# RENESAS TECHNICAL UPDATE

Product Category	MPU/MCU		Document No.	TN-RX*-A186A/E	Rev.	1.00
Title	Corrections to Descriptions for the P/E Suspend Command of Flash Memory in RX630 Group, RX63N Group, RX631 Group, RX63T Group, and RX634 Group		Information Category	Technical Notification		
Applicable Product	RX630 Group, RX63N Group, RX631 Group, RX63T Group, RX634 Group	Lot No.	Reference Document	RX630 Group User's Manual: Hardware Rev.1.60 (R01UH0040EJ0160) RX63N Group, RX631 Group User's Manual: Hardware Rev.1.80 (R01UH0041EJ0180) RX63T Group User's Manual: Hardware Rev.2.20 (R01UH0238EJ0220) RX634 Group User's Manual: Hardware Rev.1.00 (R01UH0495EJ0100)		
		All

This document describes corrections to the descriptions for the SUSRDY bit and the flow chart of the P/E suspend command in the “Flash Memory” section of User’s Manual: Hardware for the applicable products mentioned above.

Figure 43.18 Procedure for Programming/Erase Suspension

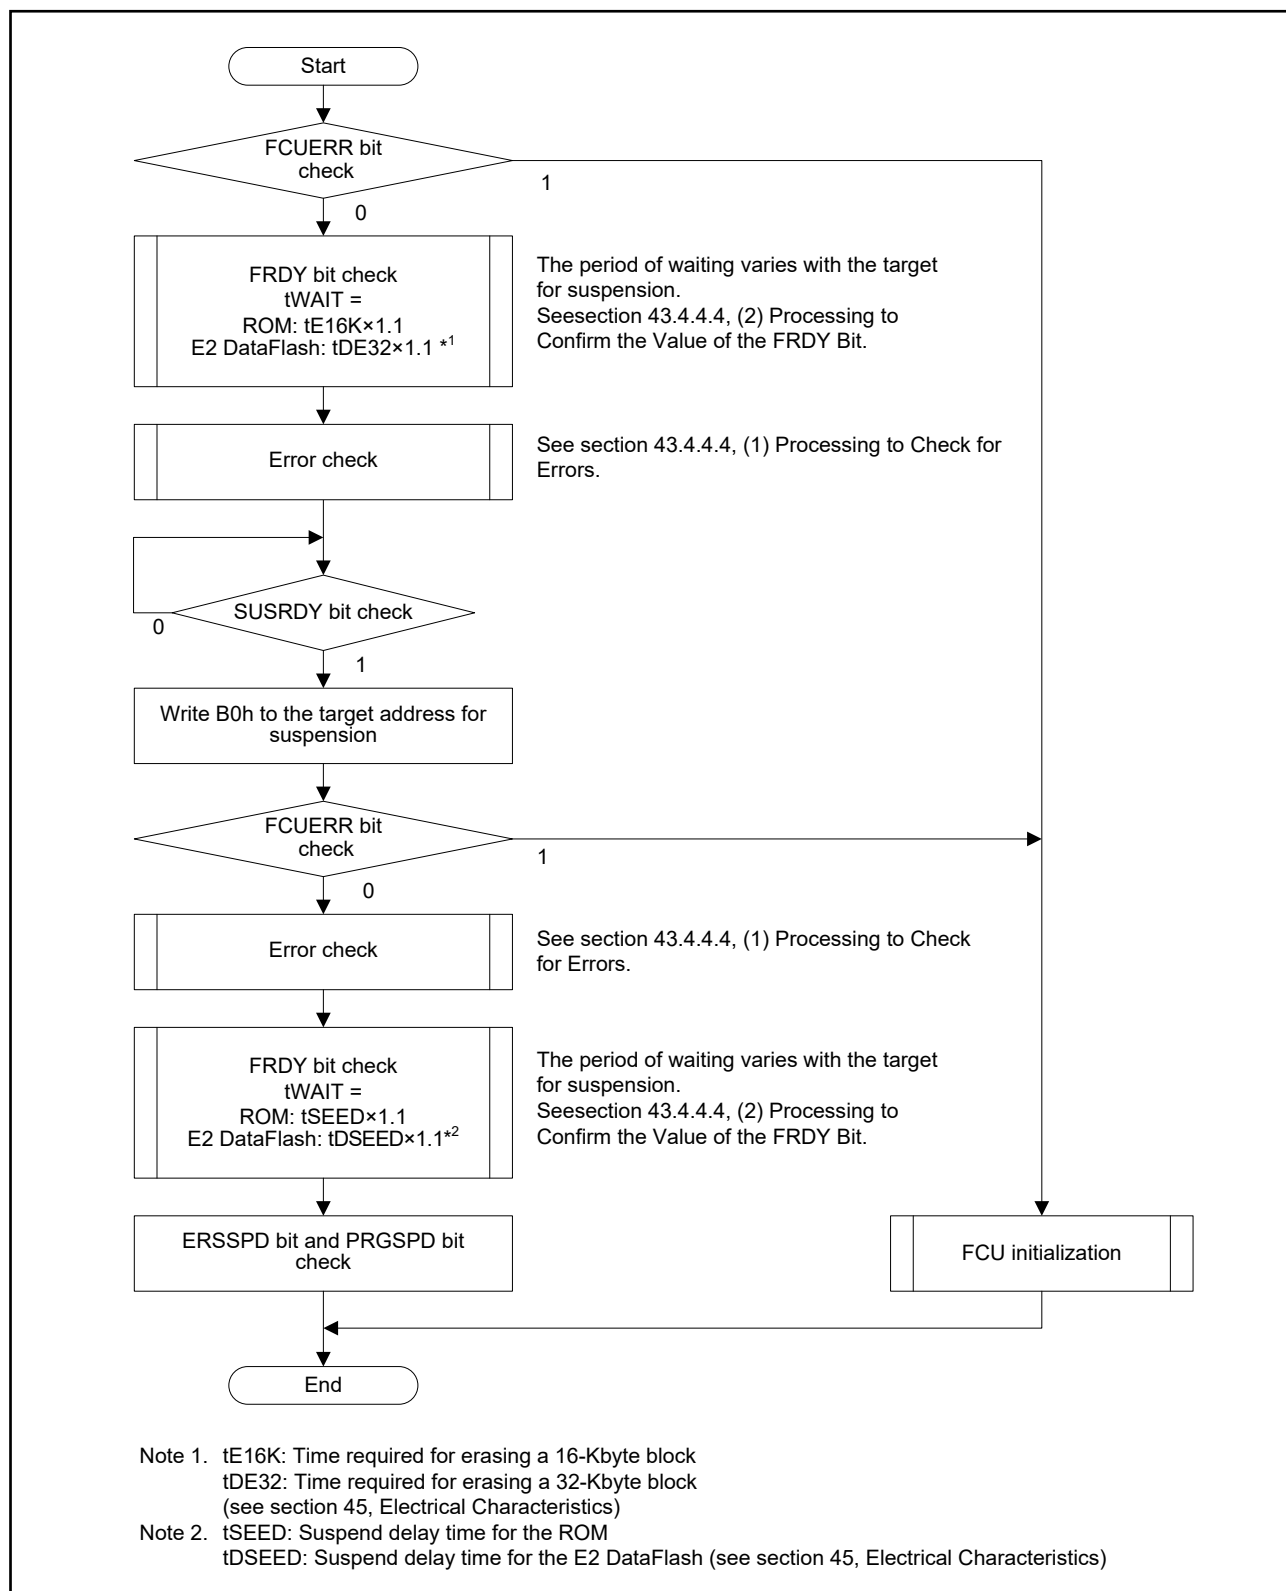
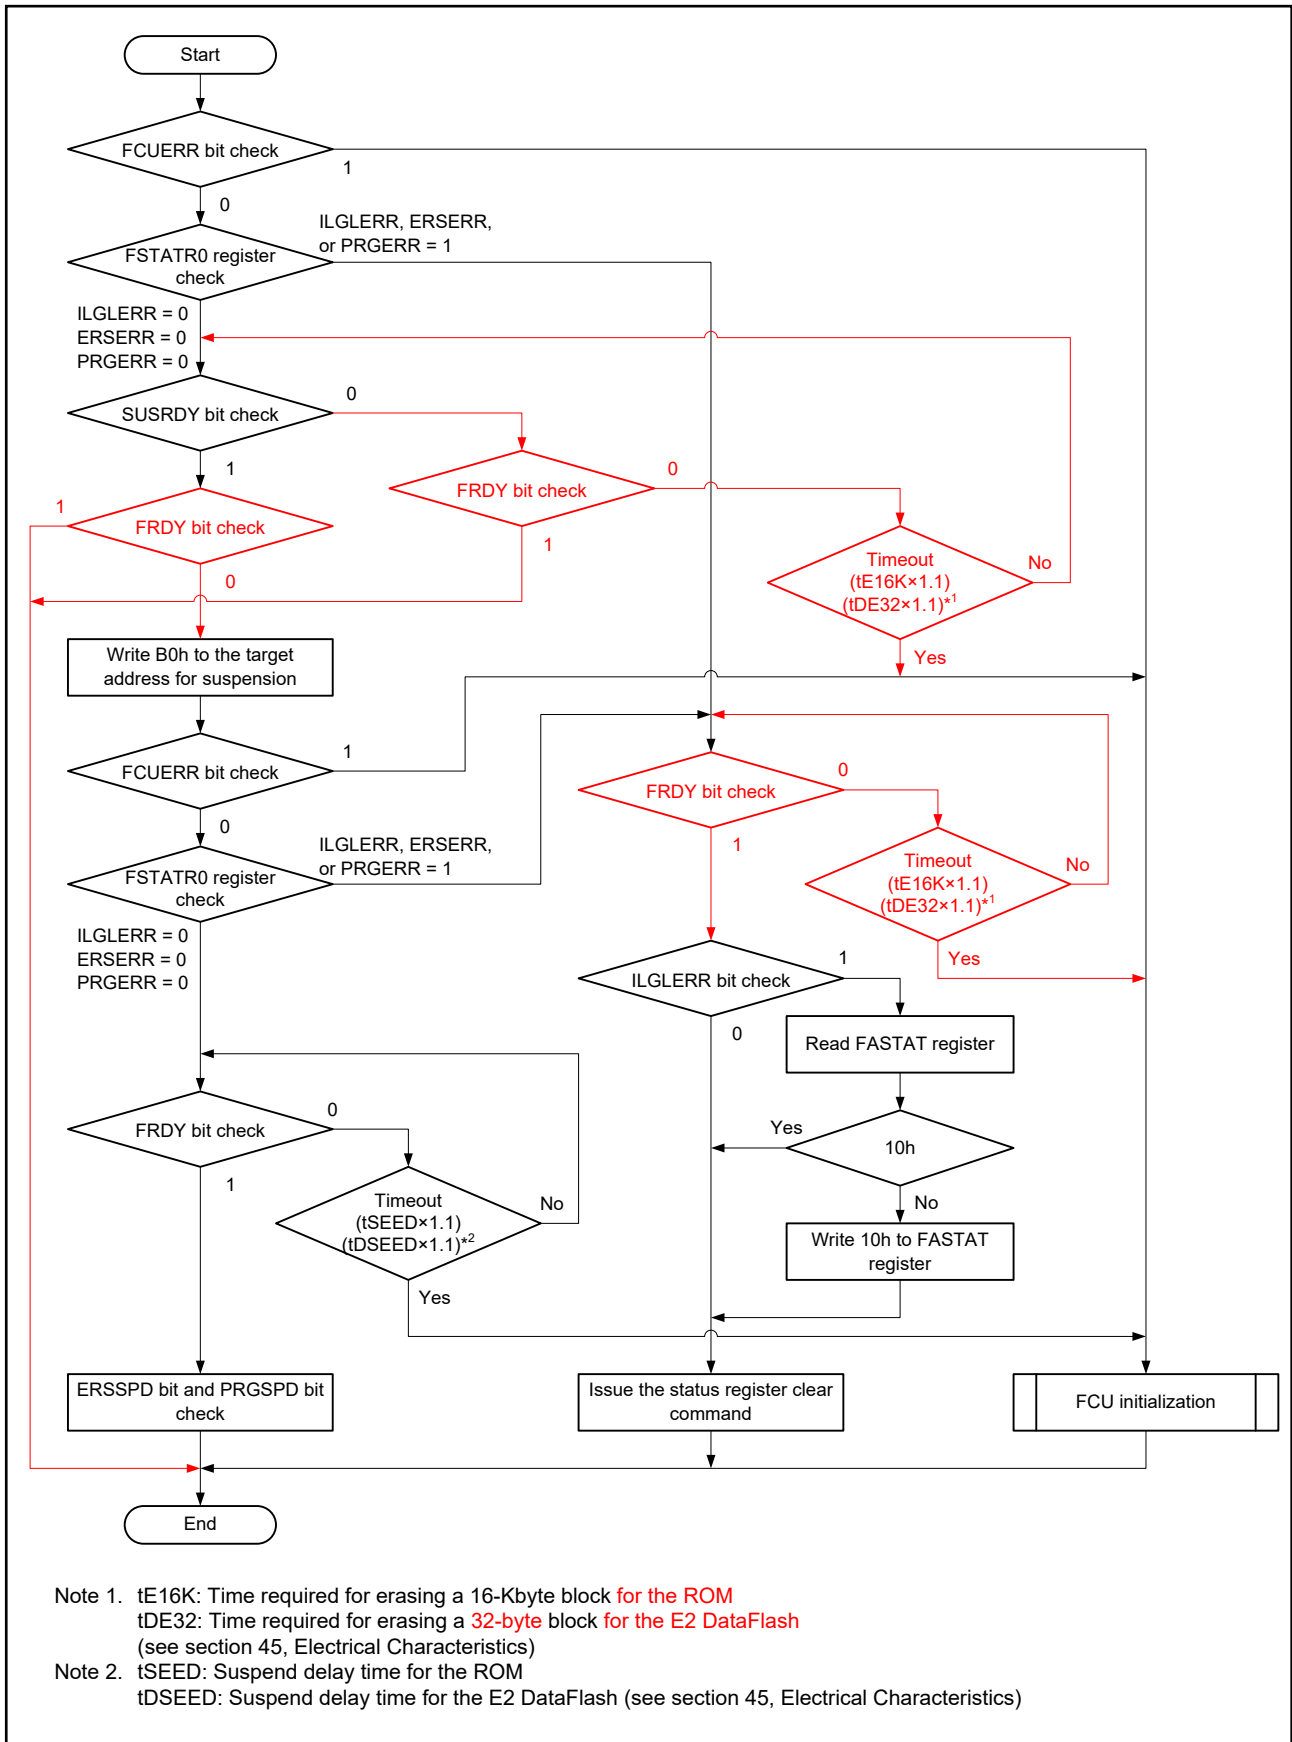
In Figure 43.18, Procedure for Programming/Erase Suspension, a processing flow never escapes from the loop for a checking procedure if the programming/erase processing completed before checking the SUSRDY bit.

Therefore, a timeout processing and a breaking processing when the FRDY bit is 1 are to be added.
